Report: TAB REPORT
Function: Test, Adjust, & Balance
Date: 05/22/2025
Completed By: National TAB

PROJECT
05-19-25 CAVA CHARLOTTE, NC
(NORTHLAKE)

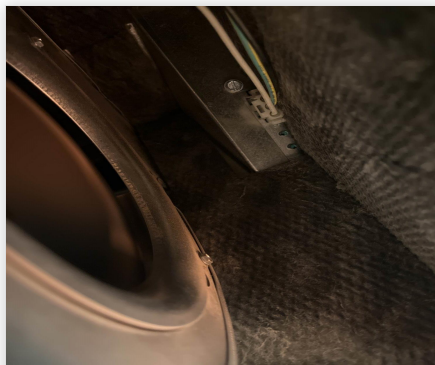
Issue Name : CEF1 & CEF2 / Speed Controllers
Description : CEF1 & CEF2 speed controllers are not installed. Unable to balance fans to design CFM.
Created By : National TAB **Assigned To :** National TAB - Dale Wheeler
Status : Open
Priority : High **Asset Tag :**
Originated Date : 05/20/2025 - Dale Wheeler - National TAB

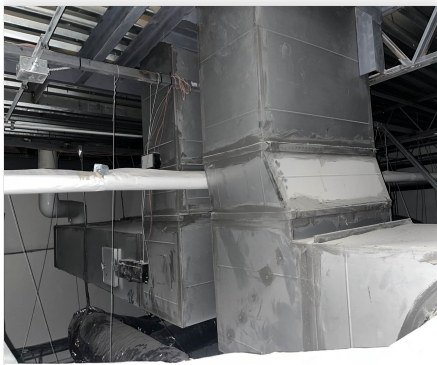
Issue Name : MAU / Gas Pipe Connection Leak
Description : MAU gas pipe connection is leaking gas. Heater is unable to be tested. Gas valve's for MAU, RTU1, RTU2 were in the off position upon arrival.
Created By : National TAB **Assigned To :** National TAB - Dale Wheeler
Status : Open
Priority : Medium **Asset Tag :**
Originated Date : 05/20/2025 - Dale Wheeler - National TAB
